VCS VERIFICATION REPORT FOR ZIQIANG 18MW HYDROPOWER PROJECT IN GUIZHOU PROVINCE CHINA

Project Title	<i>Ziqiang 18MW Hydropower Project in Guizhou Province China</i>
Version	<i>1.0</i>
Report ID	<i>EC10(C)2013001</i>

Report Title	<i>VCS Verification Report for Ziqiang 18MW Hydropower Project in Guizhou Province China</i>
Client	Guizhou Honor Carbon Asset Management Co., Ltd
Pages	35
Date of Issue	14 June 2013
Prepared By	<i>China Classification Society Certification Company</i>
Contact	40, Dong Huang Cheng Gen Nan Jie, Beijing, 100006, P.R. China, Tel: + 86 10 5811 2306 Email: ruiqiguang@c.ccs.org.cn www.ccs-c.com
Approved By	<i>Huang Shiyuan</i>
Work Carried Out By	<i>Mr. Liu Dongsan (Team Leader) Ms. Zheng Ling(Verifier) Mr. Shi Weiwei (Technical Expert and Trainee verifier)</i> <i>Mr. Rui Qiguang(Internal Technical Reviewer)</i>

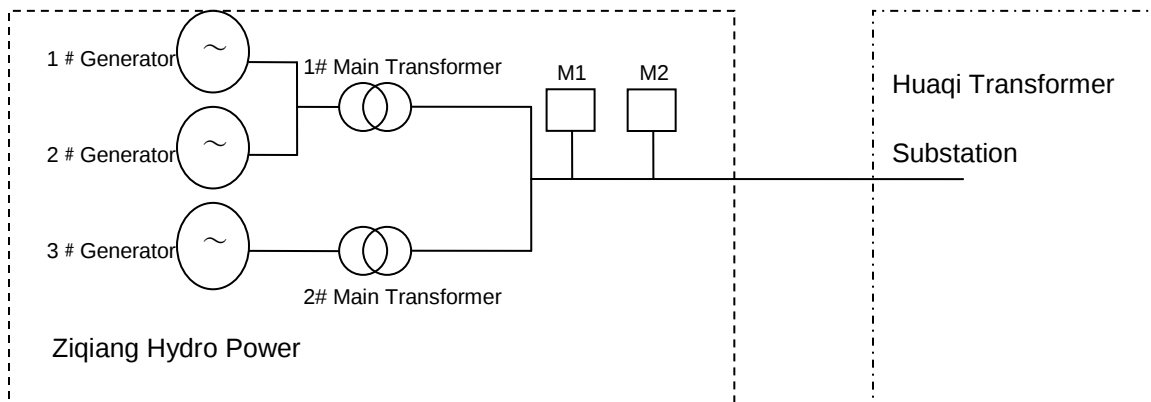
Seen from the above figure, the main meter M1 and backup meter M2 have been installed at the connection point to the grid for measuring the electricity supplied to and imported from the grid. However, the backup meter M2 was not installed until 17/04/2012. Besides, on 17/04/2012, the main meter (SN: 1006000001) was replaced by a new meter (SN: 208368946), and in VCS-MR (Version 01)/1/ the relevant information was not mentioned. **Therefore CL2 was raised.**

PP has clarified that as per the registered CDM-PDD/3/, when a malfunction of main meter occurs, the backup meter would be adopted. Since the main meter was operating in a good condition during the monitoring period and the export and import electricity was measured well by the main meter. And a backup meter has been installed on 17/04/2012 making the monitoring system fully consist with the approved MP/3/. The CCSC can confirm that the absence of the backup meter has no impact on the acquisition of electricity data during 20/12/2010 to 17/04/2012. Furthermore the information regarding the replacement of main meter has been added in VCS-MR (Version 02)/1/, the relevant evidence was also provided. Hence **CL2 was closed.**
